UNITED STATES PATENT AND TRADEMARK OFFICE

APPLICATION NO.	FILING DATE	FIRST NAMED INVENTOR	ATTORNEY DOCKET NO.	CONFIRMATION NO.
09/731,915	12/08/2000	Satoru Miyashita	101050.01	6866

Office Action Summary

DETAILED ACTION

FIG.1

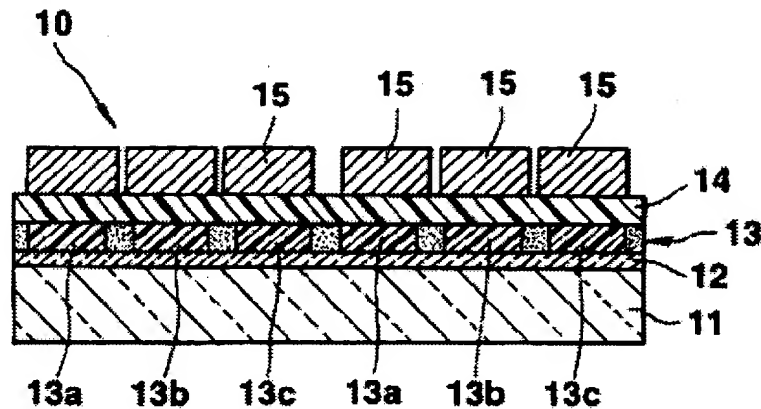
10. Shirasaki et al. teach electroluminescent devices (column 4, lines 35+). As shown in figure 1 below: The structure comprises a transparent substrate (11), transparent pixel electrodes (12), a luminescent layer (13) comprising a poly-N-vinylcabazole (PVCZ) matrix having color pixels (13a, b, c), which had been printed by ink jet or other means and then diffused, into the polymer matrix. The devices also have an electron injection layer (14) deposited over the luminescent layer and a second set of electrodes (15).

Regarding the order of layers (14), dye layer and (13), hole transfer layer It would have been obvious to one having ordinary skill in the art to have changed the order of these two layers between the electrodes (15) and (12) because the device would still function in the same capacity. The device would generate light and electrons would move between the electrodes. There in no reason to believe that the device would function materially differently from what it does now in the prior art.

FIG.7B

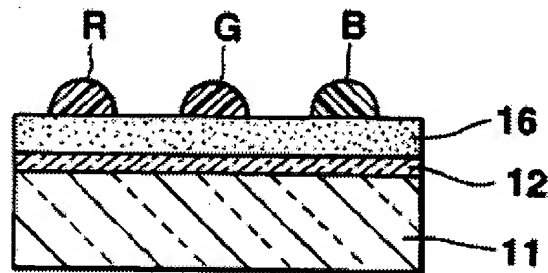
Figure 7B show the R (Red), G (Green) and B (Blue) pixels being formed on the surface of the luminescent hole transport layer (16), by a lithographic (coating) or ink jet method (column 7, lines 14+). These pixels represent discontinuous non-overlapping layers and meet the requirement that there are three colored layers

These pixels have predetermined shape when printed, and this relates to the dot shape of the pixels in the final product. While a diffusion step occurs in the formation of the structures, this does not detract from the fact that the shape of the printed pixel is the shape of the pixel in

the final product. Regarding claim 40, because the colored pixels do not overlap, they do not build on themselves. Each layer of colored pixels covers different areas of the substrate layer. Thus, the layers applied in any order would result in the same product. Once the droplets (figure 7b) diffuse they would spread and the boundaries of each of the droplets would come in contact with the adjoining droplets and touch as claimed..
